REMARKS/ARGUMENTS

In view of the foregoing amendments and the following remarks, reconsideration of this application is requested. Claims 1-2, 4, 6-9, 11, 13-16, and 18-22 are now pending with claims 1, 6, 8, 13, 15, and 20 being independent. Claims 3, 5, 10, 12, and 17 have been canceled. Claims 1, 6, 8, 13, 15, and 20 have been amended.

FIG. 6a

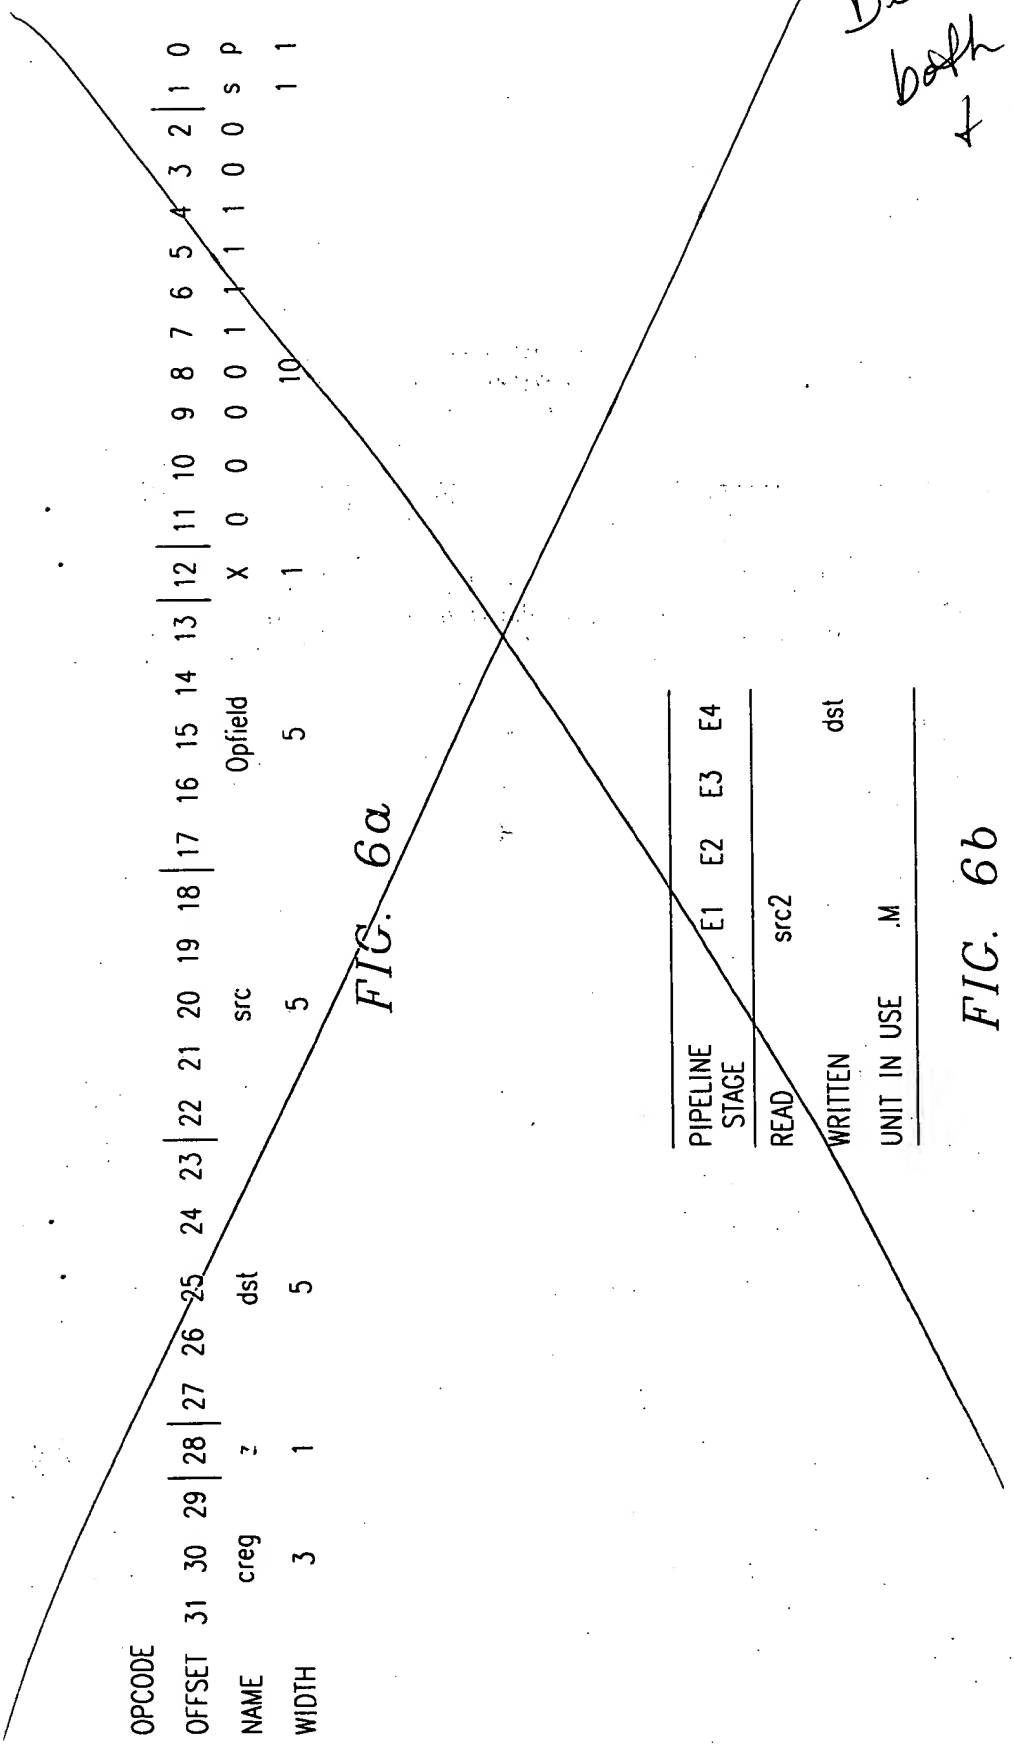
Delete both 6a & 6b
